PREDEVELOPMENT PLAN REVIEW COMMENTS

Project Number: PPR2019-00014
Date: March 10, 2020
Project Address: 1000 East Walnut Street
Project Description:

Review of preliminary plans for demolition of an existing two-story, 20,295 sq. ft., commercial building and the establishment of a Supportive Housing land use, to be located within a new four-story, 47,193 sq. ft. Single-Room Occupancy (SRO) facility. The Supportive Housing land use would consist of 65 very-low income supportive housing units, a manager’s unit and two studio units for staff. A 8,859 square foot Charitable Institution land use is proposed on the ground floor.

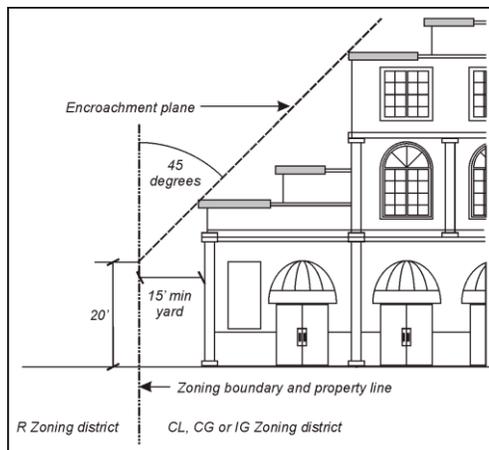
Pursuant to Section to PMC 17.24.040, Table 2-6, Note 5, The front and rear setback requirements for a project with more than 25,000 square feet of floor area shall be determined as part of the Conditional Use Permit approval for the project. The project proposes more than 25,000 of gross floor area, therefore the setback requirements will be determined as part of the Conditional Use Permit process. The project proposes the following front and corner side setbacks:

- a) Front Setback (Catalina Avenue): 14'2" setback.
- b) Corner Setback (Walnut Avenue): 13'1" to 25'-8" setback.

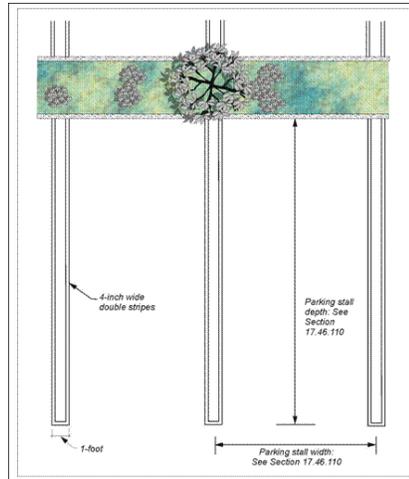
- b) Charitable Institution: Per Section 17.46.040, required parking is specified via a Conditional Use Permit. A parking demand analysis, prepared by a licensed professional, may be requested to substantiate the proposed parking requirement.

The project, at this time, proposes 16 parking spaces for the 8,859 sq. ft. Charitable Institution land use; equivalent to approximately 2 parking spaces for every 1,000 sq. ft. of floor area.
